**CONCEPT EVALUATIONS
And
COMMENTS RECEIVED**

**LINWOOD/EASTERN AVENUE
INTERCHANGE FOCUS AREA**

Eastern Corridor Segments II and III

Remove Parking Along Inside Edge of Square

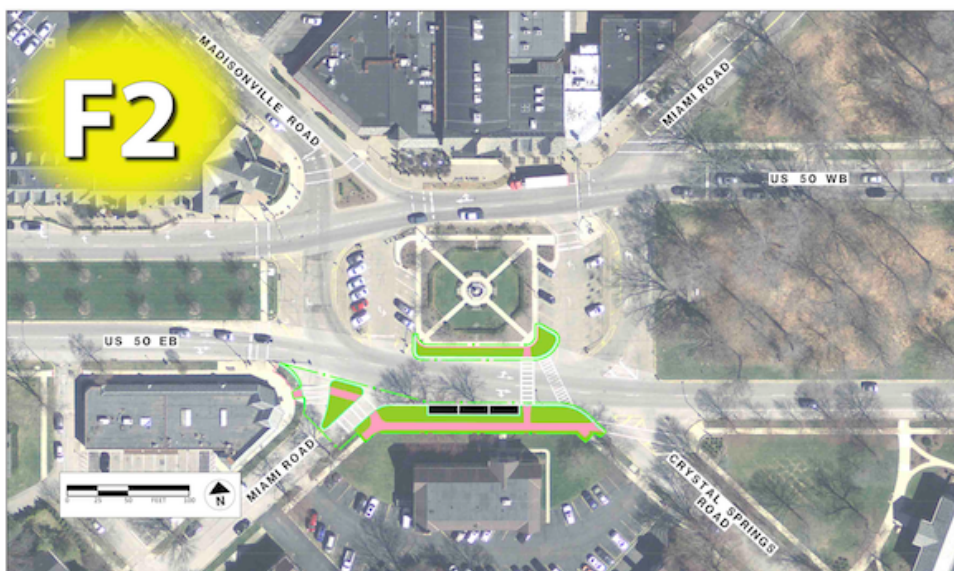
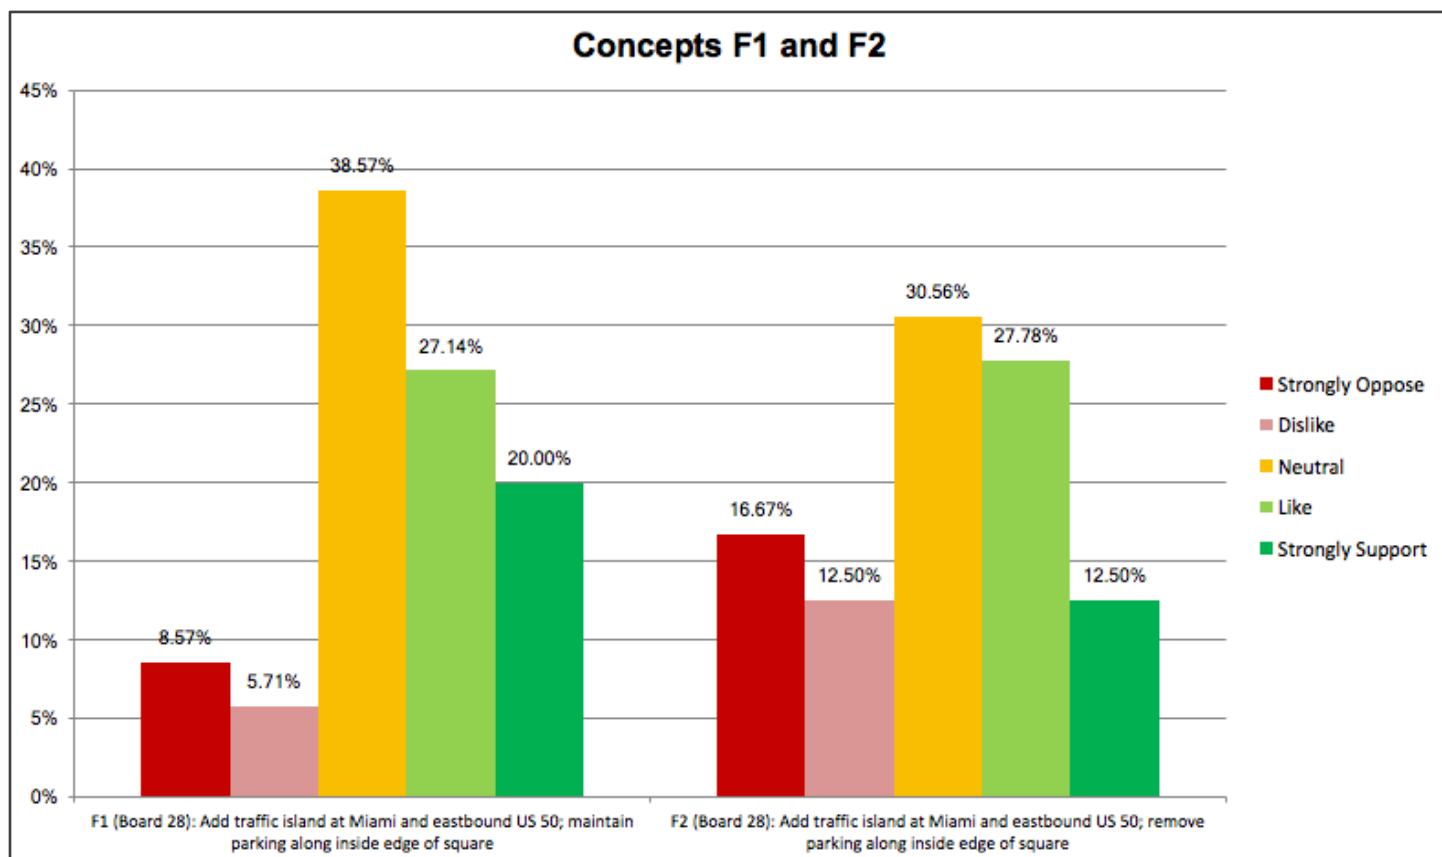
NO.	COMMENT	RESPONSE
1	F1 and F2 - while the amounts are small, I just don't see these as needed improvements.	Thank you for your comment. Your input is appreciated and will be taken into consideration as we evaluate the options and develop our recommendations.
2	F1 - An island does not need to be added to Miami, one is there and is sufficient and a bigger island would have pedestrians ignore the lights. Parking must be maintained on the square for businesses.	Thank you for your comment. Your input is appreciated and will be taken into consideration as we evaluate the options and develop our recommendations.

NO.	COMMENT	RESPONSE
3	I run through Mariemont often and there just is no reason for F1 or F2 to be done as I've never felt unsafe on the streets or sidewalks there.	Thank you for your comment. Your input is appreciated and will be taken into consideration as we evaluate the options and develop our recommendations.

NO.	COMMENT	RESPONSE
1	F1 and F2 - While the amounts are small, I just don't see these as needed improvements.	Thank you for your comment. Your input is appreciated and will be taken into consideration as we evaluate the options and develop our recommendations.
2	F2 - Strongly disagree with two lanes going into Mariemont between Petoskey and East St. since traffic slows down now to move into the one lane and makes it possible for cars exiting from the south of the pike to enter the pike, two lanes, even with a proposed decrease in speed will not occur without slowing down to merge. The island on Madisonville Road by the Inn should be decreased since two large SUV's side by side at the light are too tight. You need a right turn lane on Wooster at Watterson and arrows in the middle lane of Fairfax on the bricks so cars know they can drive on it if they are making a turn and not stop all of the traffic to turn left into businesses going westbound. Mariemont Square does not need to be changed except for the Island by the Inn, decreased in size.	<p>Thank you for your comment. Your input is appreciated and will be taken into consideration as we evaluate the options and develop our recommendations.</p> <p>Subsequent to the public meetings in October, the Mariemont Planning Commission voted in January 2019 to not approve maintaining two travel lanes in each direction on US 50 between East Street and Petosky Avenue. Therefore, the proposed lane modification will not be taking place in conjunction with the proposed resurfacing work (PID 101309) in 2019 (see F6).</p>

3	I run through Mariemont often and there just is no reason for F1 or F2 to be done as I've never felt unsafe on the streets or sidewalks there.	Thank you for your comment. Your input is appreciated and will be taken into consideration as we evaluate the options and develop our recommendations.

F4

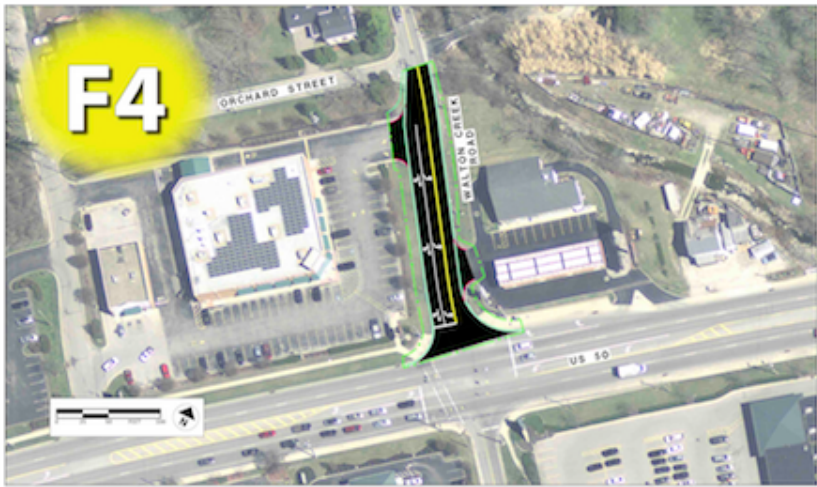
NO.	COMMENT	RESPONSE
1	F4 - Desperately needed; rush hour traffic is horrible at that intersection if you are on Walton Creek. The problem is also	Thank you for your comment. Your input is appreciated and will be taken into consideration as we evaluate the options and develop our recommendations.

NO.	COMMENT	RESPONSE
	compounded by the Kroger (and other businesses) traffic turning east onto Wooster, which slows the ability for Walton Creek traffic to turn.	In the fall of 2018, ODOT installed a southbound left turn phase as a short-term improvement, and based on field observations, this improvement has successfully reduced delay on this approach.

Concepts F3, F4 and F5

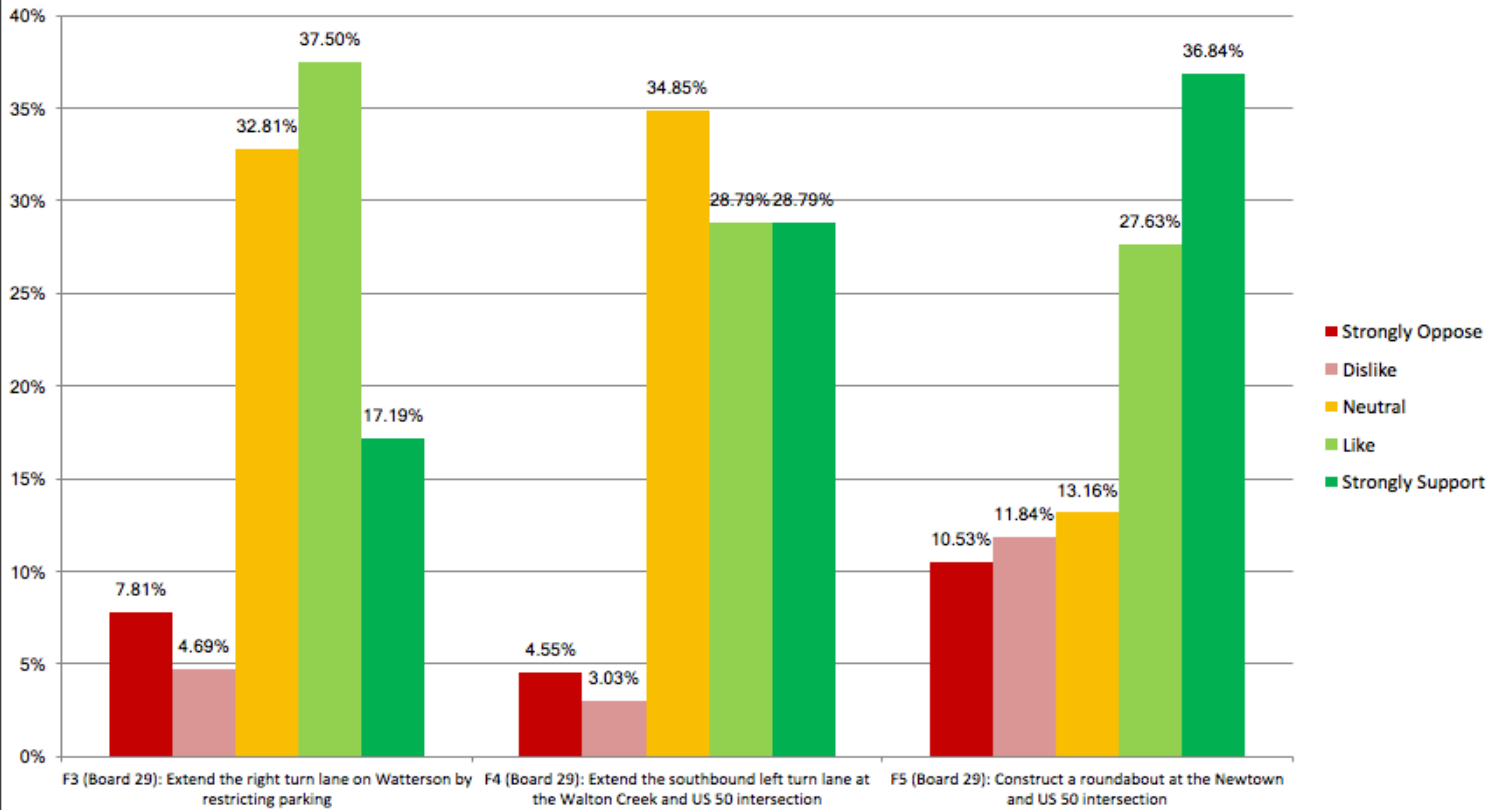
NO.	COMMENT	RESPONSE
1	F5 - Yes, please!	Thank you for your comment. Your input is appreciated and will be taken into consideration as we evaluate the options and develop our recommendations.

Maintain Two Lanes in Each Direction on US 50 at Chicane

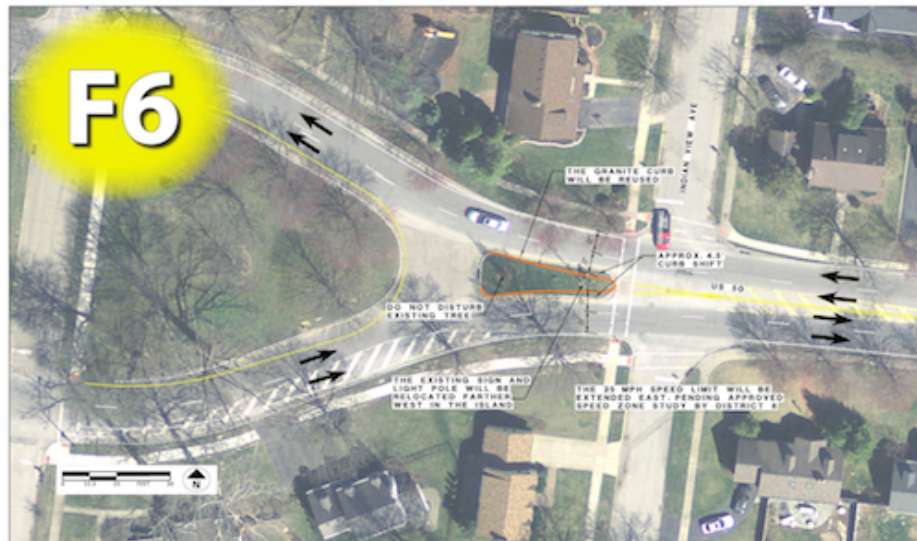
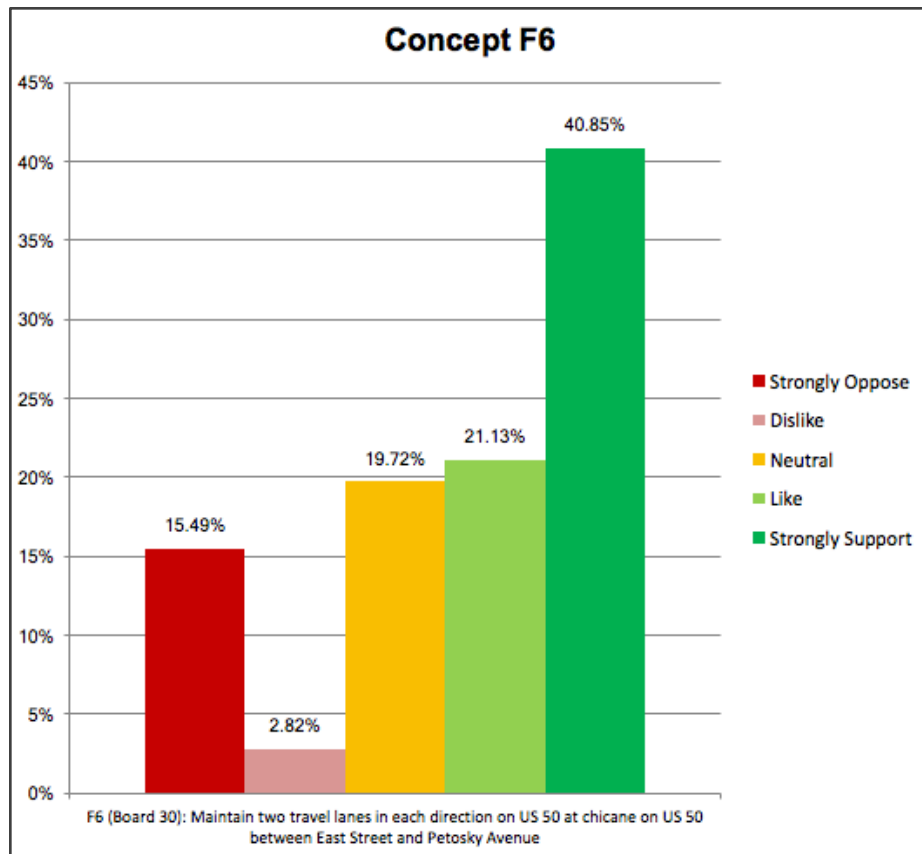
NO.	COMMENT	RESPONSE
1	Consideration to new high school construction on F6. Too much construction in one area.	<p>Thank you for your comment. Your input is appreciated and will be taken into consideration as we evaluate the options and develop our recommendations.</p> <p>Subsequent to the public meetings in October, the Mariemont Planning Commission voted in January 2019 to not approve the proposed change. Therefore, the lane modification will not be taking place in conjunction with the proposed resurfacing work (PID 101309) in 2019; however, Mariemont High School is moving forward with a traffic study to request access to the traffic signal at the Mariemont Promenade via ODOT permit.</p>

NO.	COMMENT	RESPONSE
2	F6 - Seems like an obvious win with the benefit loss ratio	<p>Thank you for your comment. Your input is appreciated and will be taken into consideration as we evaluate the options and develop our recommendations.</p> <p>Subsequent to the public meetings in October, the Mariemont Planning Commission voted in January 2019 to not approve the proposed change. Therefore, the lane modification will not be taking place in conjunction with the proposed resurfacing work (PID 101309) in 2019.</p>
3	<p>F6 - The current traffic pattern that forces through traffic to one lane allows local traffic (especially access from residences on the south side of 50) to more easily turn onto 50 headed east, cross over to the square, and to make left turns when headed west on 50. The proposed change could result in additional traffic accidents, especially rear ends as local residents headed west on 50 turn left to East Street, Indianview, and Petosky. Also, continuous flow of two lanes of traffic could make pedestrian crossing of 50 more difficult at several locations. This would be a major change to Nolen's plan, affecting a National Historic Landmark. And board 30 related to F6 title states "Maintain two lanes in each direction on US50 at Chicane" which is inaccurate and extremely misleading. The plan and images show the intersection of 50 and Indianview.</p>	<p>Thank you for your comments. Your input is appreciated and will be taken into consideration as we evaluate the options and develop our recommendations.</p> <p>ODOT will follow the Section 106 Consultation Process in coordinating any proposed work within the boundary of the Village of Mariemont National Historic Landmark with the State Historic Preservation Office, National Park Service, and Section 106 Consulting Parties prior to implementing/constructing any proposal.</p> <p>Subsequent to the public meetings in October, the Mariemont Planning Commission voted in January 2019 to not approve the proposed change. Therefore, the lane modification will not be taking place in conjunction with the proposed resurfacing work (PID 101309) in 2019.</p>

4	F6 Board 30. Widening SR50 east of the Mariemont Square. John Nolan the notable Mariemont city planner got approval in the 1920's from the State of OH to change SR50 to put in the single lane curve. Since Nolan's street plan was a large part of obtaining Historic Landmark designation for the village. I do not believe the State of OH can change a street plan which is part of an Historic designation.	<p>Thank you for your comments. Your input is appreciated and will be taken into consideration as we evaluate the options and develop our recommendations.</p> <p>The Ohio Department of Transportation, as part of the Section 106 Consultation, has consulted with Ohio's State Historic Preservation Office and the National Park Service, regarding the effects of the subject undertaking on The Village of Mariemont, which is a National Historic Landmark. The proposed undertaking involves maintenance activities and minor alterations to traffic patterns and one traffic island on Wooster Pike (US-50) in the Village of Mariemont, Hamilton County. The project would be constructed partially within the boundary of the Village of Mariemont National Historic Landmark (NRHP #07000431). The project would not require new right-of-way, and no contributing features of the historic district would be removed by the undertaking.</p>

NO.	COMMENT	RESPONSE
7	F6 - Drivers will be encouraged to speed through there.	<p>Thank you for your comment. Your input is appreciated and will be taken into consideration as we evaluate the options and develop our recommendations.</p> <p>Subsequent to the public meetings in October, the Mariemont Planning Commission voted in January 2019 to not approve the proposed change. Therefore, the lane modification will not be taking place in conjunction with the proposed resurfacing work (PID 101309) in 2019.</p>
8	F6 is absolutely necessary but with improved signage for the lane ending in Mariemont. That bottleneck is a completely avoidable headache.	<p>Thank you for your comment. Your suggestion is appreciated and will be taken into consideration as we evaluate the options and develop our recommendations.</p> <p>Subsequent to the public meetings in October, the Mariemont Planning Commission voted in January 2019 to not approve the proposed change. Therefore, the lane modification will not be taking place in conjunction with the proposed resurfacing work (PID 101309) in 2019.</p>

9	On F6, Board 30 - I STRONGLY support this as I've been in many instances where drivers have either cut me off/accelerated at a high rate or been close to an accident due to this Chicane. It's very dangerous, doesn't slow traffic and needs to go since very few people operate their vehicle responsibly in the current setup.	<p>Thank you for your comment. Your input is appreciated and will be taken into consideration as we evaluate the options and develop our recommendations.</p> <p>Subsequent to the public meetings in October, the Mariemont Planning Commission voted in January 2019 to not approve the proposed change. Therefore, the lane modification will not be taking place in conjunction with the proposed resurfacing work (PID 101309) in 2019.</p>
10	I strongly oppose enlarging US 50 through Mariemont. It will create more traffic, further divide Mariemont into two communities during high traffic times. Mariemont is a functioning, walkable community that happens to straddle an increasingly busy thoroughway. If changes to US 50 occur, the quality of life in the unique Village of Mariemont will be negatively affected. You simply can't make US 50 into a highly efficient, highly traveled highway AND have a functioning community. The quality of life in the uniquely designed Village of Mariemont is not something that can be compromised--as we've been saying for the 50 or so years that this topic has been discussed.	<p>Thank you for your comments. Your input is appreciated and will be taken into consideration as we evaluate the options and develop our recommendations.</p> <p>The Ohio Department of Transportation, as part of the Section 106 Consultation, has consulted with Ohio's State Historic Preservation Office and the National Park Service, regarding the effects of the subject undertaking on The Village of Mariemont, which is a National Historic Landmark. The proposed undertaking involves maintenance activities and minor alterations to traffic patterns and one traffic island on Wooster Pike (US-50) in the Village of Mariemont, Hamilton County. The project would be constructed partially within the boundary of the Village of Mariemont National Historic Landmark (NRHP #07000431). The project would not require new right-of-way, and no contributing features of the historic district would be removed by the undertaking.</p> <p>ODOT will continue to follow the Section 106 Consultation Process in coordinating any proposed work within the boundary of the Village of Mariemont National Historic Landmark with the State Historic Preservation Office,</p>

NO.	COMMENT	RESPONSE
		<p>ODOT will continue to follow the Section 106 Consultation Process in coordinating any proposed work within the boundary of the Village of Mariemont National Historic Landmark with the State Historic Preservation Office, National Park Service, and Section 106 Consulting Parties prior to implementing/constructing any proposal.</p> <p>Subsequent to the public meetings in October, the Mariemont Planning Commission voted in January 2019 to not approve the proposed change. Therefore, the lane modification will not be taking place in conjunction with the proposed resurfacing work (PID 101309) in 2019.</p>
5	<p><i>(The following comment has been moved from SR 125/SR 32 Miscellaneous comments section):</i></p> <p>Did not see what I want to comment on. I want to comment on SR50 to the east of Mariemont widening. John Nolan the noted city planner of Mariemont (one of the factors for the Historic Landmark designation) got specific approval from the State of Ohio in the 1920's to put in that 1 lane curve in SR50. Since the city street plan is historic, I do not believe the state of OH can change a street layout.</p>	<p>Thank you for your comments. Your input is appreciated and will be taken into consideration as we evaluate the options and develop our recommendations.</p> <p>The Ohio Department of Transportation, as part of the Section 106 Consultation, has consulted with Ohio's State Historic Preservation Office and the National Park Service, regarding the effects of the subject undertaking on The Village of Mariemont, which is a National Historic Landmark. The proposed undertaking involves maintenance activities and minor alterations to traffic patterns and one traffic island on Wooster Pike (US-50) in the Village of Mariemont, Hamilton County. The project would be constructed partially within the boundary of the Village of Mariemont National Historic Landmark (NRHP #07000431). The project would not require new right-of-way, and no contributing features of the historic district would be removed by the undertaking.</p>

<p>ODOT will continue to follow the Section 106 Consultation Process in coordinating any proposed work within the boundary of the Village of Mariemont National Historic Landmark with the State Historic Preservation Office, National Park Service, and Section 106 Consulting Parties prior to implementing/constructing any proposal.</p> <p>Subsequent to the public meetings in October, the Mariemont Planning Commission voted in January 2019 to not approve the proposed change. Therefore, the lane modification will not be taking place in conjunction with the proposed resurfacing work (PID 101309) in 2019.</p>
6	<p>F6 - This plan results in a HUGE improvement in congestion reduction and facilitates traffic flow.</p>	<p>Thank you for your comment. Your input is appreciated and will be taken into consideration as we evaluate the options and develop our recommendations.</p> <p>Subsequent to the public meetings in October, the Mariemont Planning Commission voted in January 2019 to not approve the proposed change. Therefore, the lane modification will not be taking place in conjunction with the proposed resurfacing work (PID 101309) in 2019.</p>

NO.	COMMENT	RESPONSE
		<p>National Park Service, and Section 106 Consulting Parties prior to implementing/constructing any proposal.</p> <p>Subsequent to the public meetings in October, the Mariemont Planning Commission voted in January 2019 to not approve the proposed change. Therefore, the lane modification will not be taking place in conjunction with the proposed resurfacing work (PID 101309) in 2019.</p>
11	<p>Strongly disagree with two lanes going into Mariemont between Petoskey and East St. since traffic slows down now to move into the one lane and makes it possible for cars exiting from the south of the pike to enter the pike, two lanes, even with a proposed decrease in speed will not occur without slowing down to merge. The island on Madisonville road by the Inn should be decreased since two large SUV's side by side at the light are too tight. You need a right turn lane on Wooster at Watterson and arrows in the middle lane of Fairfax on the bricks so cars know they can drive on it if they are making a turn and not stop all of the traffic to turn left into businesses going westbound. Mariemont Square does not need to be changed except for the Island by the Inn, decreased in size.</p>	<p>Thank you for your comments. Your input is appreciated and will be taken into consideration as we evaluate the options and develop our recommendations.</p> <p>The Ohio Department of Transportation, as part of the Section 106 Consultation, has consulted with Ohio's State Historic Preservation Office and the National Park Service, regarding the effects of the subject undertaking on The Village of Mariemont, which is a National Historic Landmark. The proposed undertaking involves maintenance activities and minor alterations to traffic patterns and one traffic island on Wooster Pike (US-50) in the Village of Mariemont, Hamilton County. The project would be constructed partially within the boundary of the Village of Mariemont National Historic Landmark (NRHP #07000431). The project would not require new right-of-way, and no contributing features of the historic district would be removed by the undertaking.</p> <p>ODOT will continue to follow the Section 106 Consultation Process in coordinating any proposed work within the boundary of the Village of Mariemont National Historic Landmark with the State Historic Preservation Office, National Park Service, and Section 106 Consulting Parties prior to implementing/constructing any proposal.</p> <p>Subsequent to the public meetings in October, the Mariemont Planning Commission voted in January 2019 to not approve the proposed change. Therefore, the lane modification will not be taking place in conjunction with the proposed resurfacing work (PID 101309) in 2019.</p>
